City of Rockwall, Texas

APPLICATION AND
PRELIMINARY PLAT CHECKLIST

Name of Proposed Subdivision HARBOR LANDING PHASE TWO

PLAT REVIEW

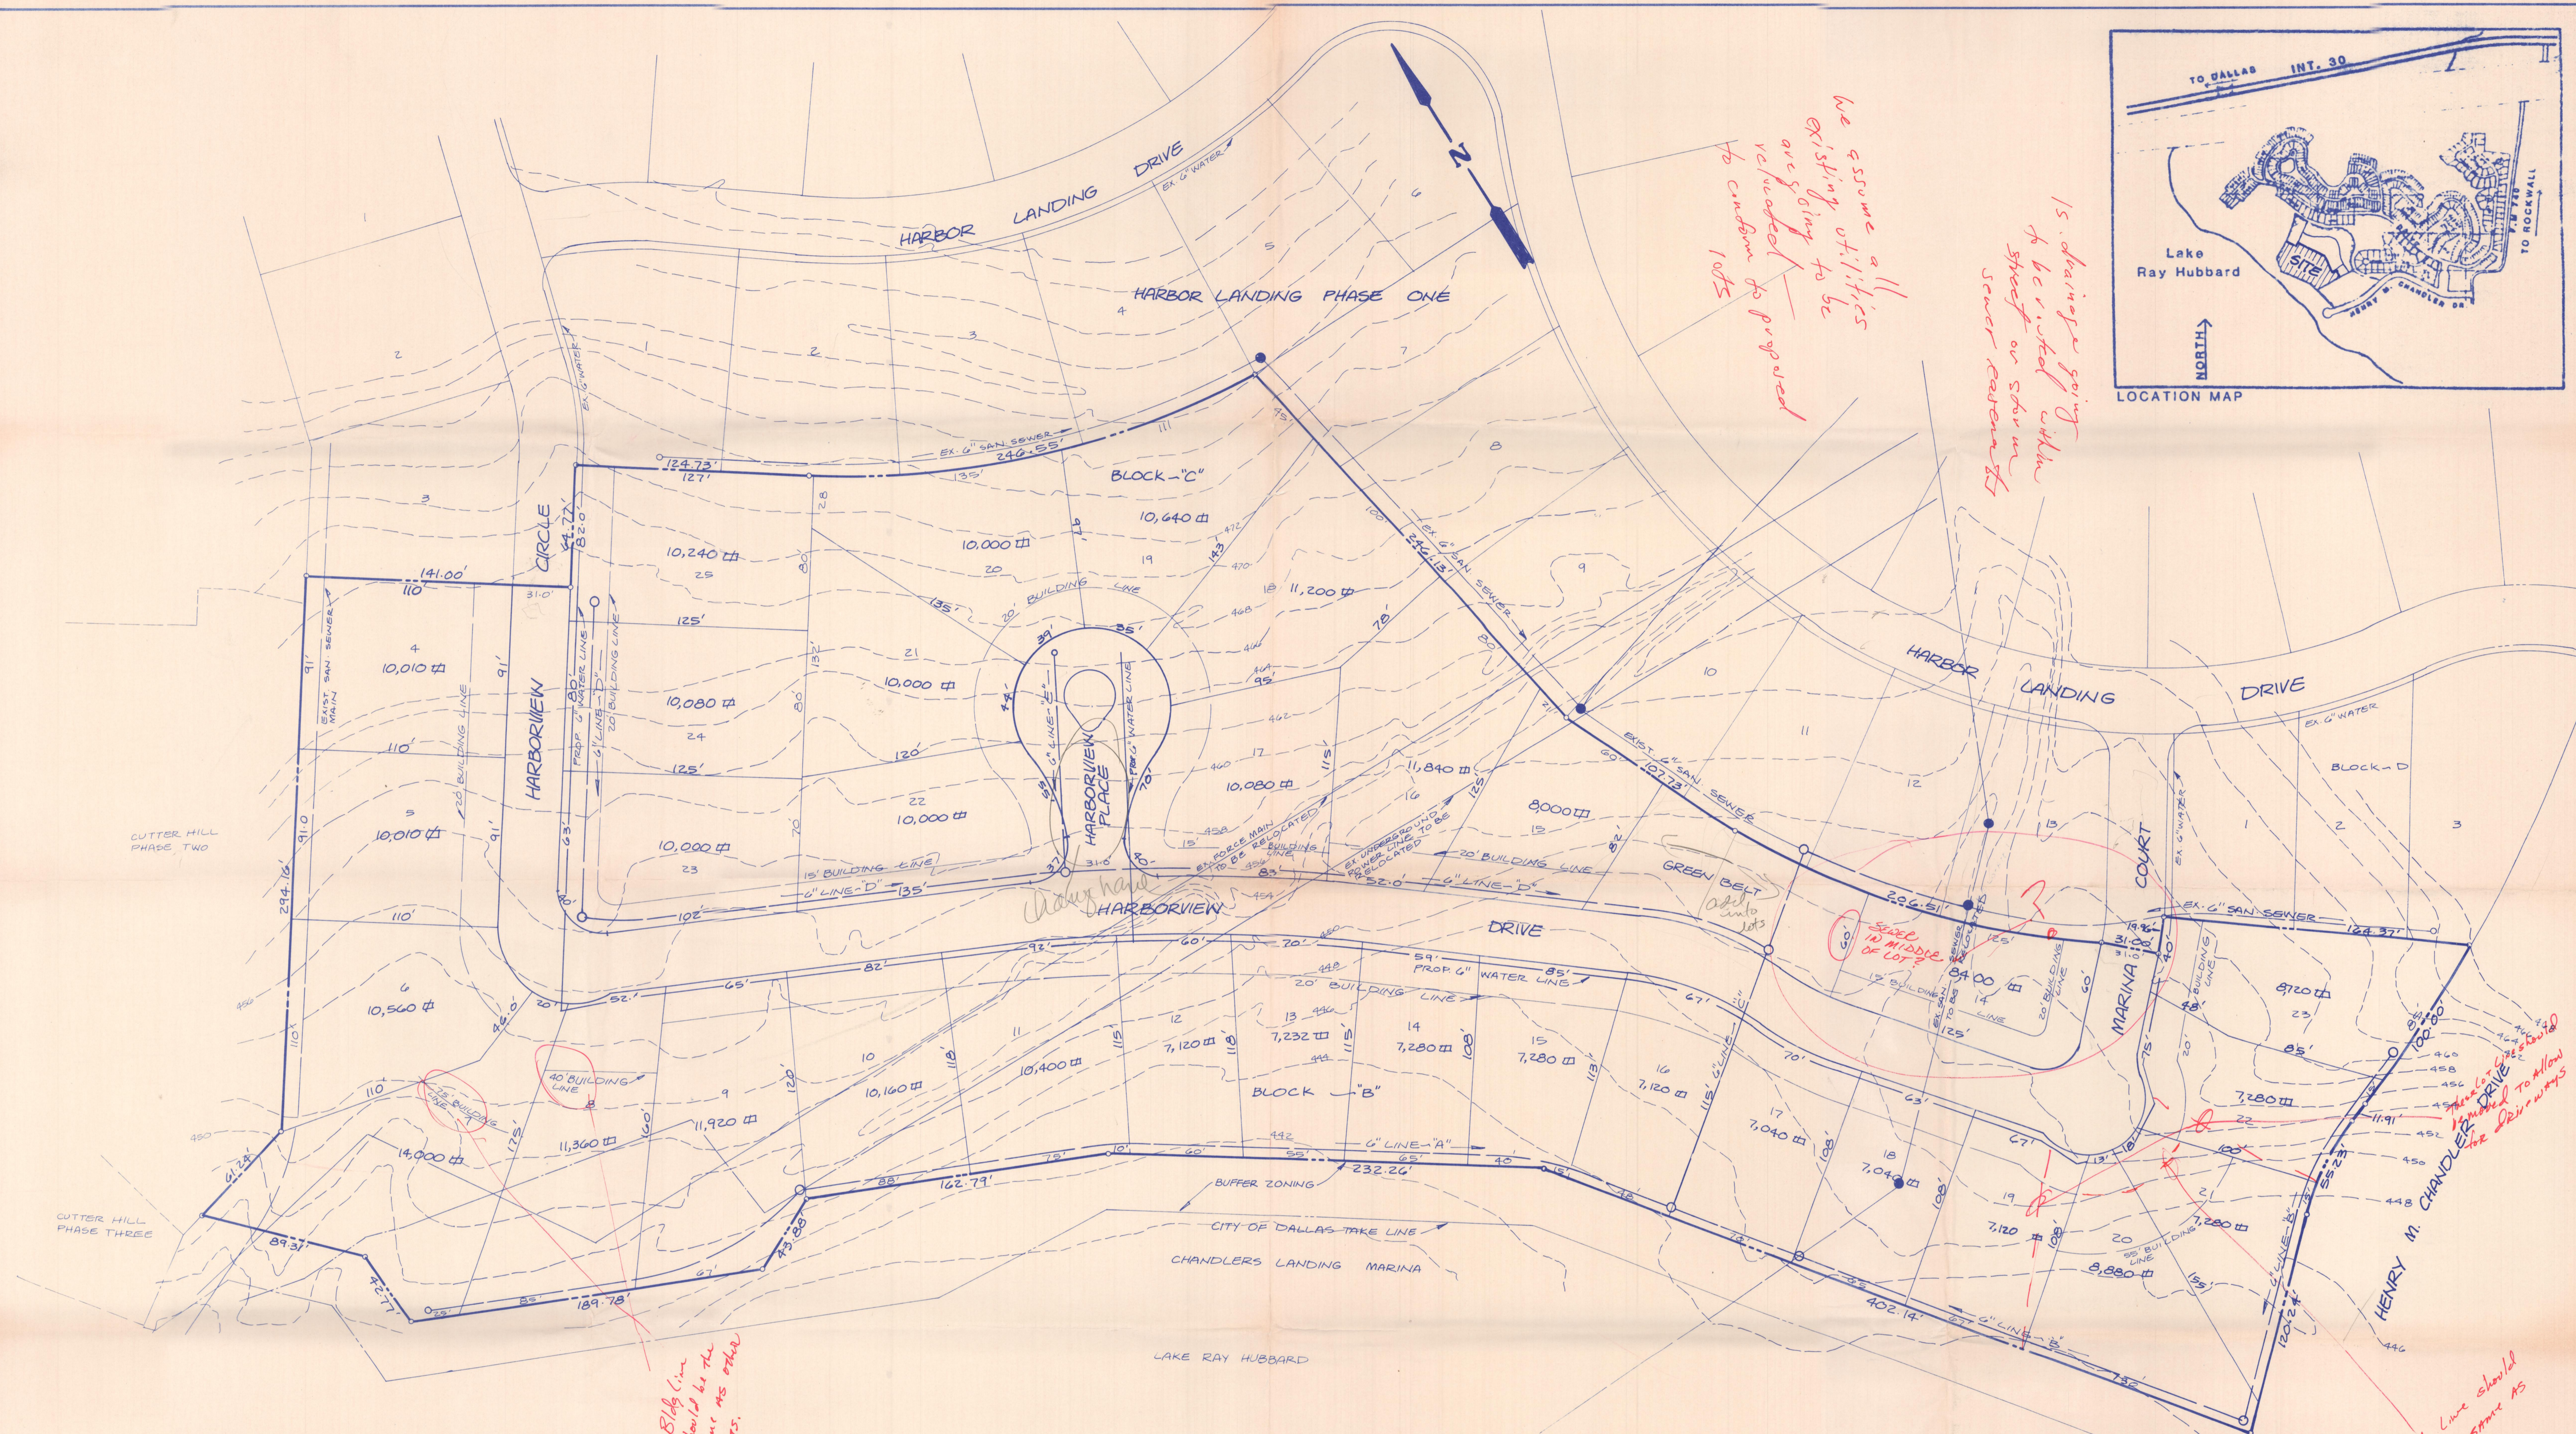
We assume all existing utilities are going to be relocated to conform to proposed lots

15 drainage going to be routed within street or shown sewer easements

Block line should be the same as other lots.

Block line should be the same as other lots.

- 1) one street name be given for street indicated as Harborview Circle/Harborview Drive/Marina Court; Marina is not a recommended street name as a street by that name currently exists
- 2) the greenbelt be incorporated into Lots 14 and 15, Block C
- 3) revision to lots with minimal frontage.

There are several technical changes we would like to see. The street names are confusing with Harborview Place, Circle and Drive, and we already have a Marina Drive. We have asked them to change those. We have also asked them to incorporate the greenbelt into the 2 adjacent lots and to add more lot frontage to lots 20 and 21.

There are several technical changes we would like to see. The street names are confusing with Harborview Place, Circle and Drive, and we already have a Marina Drive. We have asked them to change those. We have also asked them to incorporate the greenbelt into the 2 adjacent lots and to add more lot frontage to lots 20 and 21. They have agreed to make all these changes and they are reflected on the final plat.
